ITEM 3 – R SUBDIVISION

KPB File No.	2022-091R1
Plat Committee Meeting:	October 24, 2022
Applicant / Owner:	Jessica and Brian Ranguette of Nikiski, AK
Surveyor:	Jason Young, Mark Aimonetti / Edge Survey and Design, LLC
General Location:	Gravel Pit Trail, Caribou Hills, Ninilchik

STAFF REPORT

BUILDING SETBACK AND UTILITY EASEMENT TYPICAL - SCALE 1" = 50'

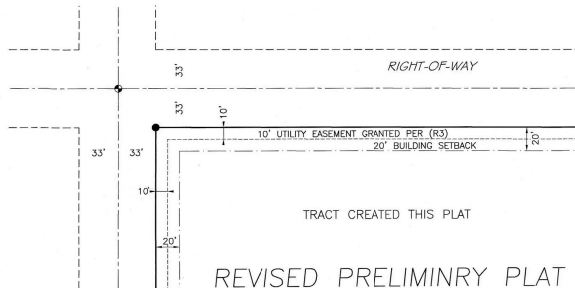
Utility Easements the Right of Way Map, HM 84-115, granted 10-foot-wide utility easements along the dedicated rights-of-way. Staff recommends revising plat note 3 slightly. A typical drawing is being included on the plat.

- Note 3, updated by removing “of the building setback”.
- Update the portion of code for the exception to 20.40.100 and add “... Code 20.40.100 to not require a soils analysis and report was granted...”
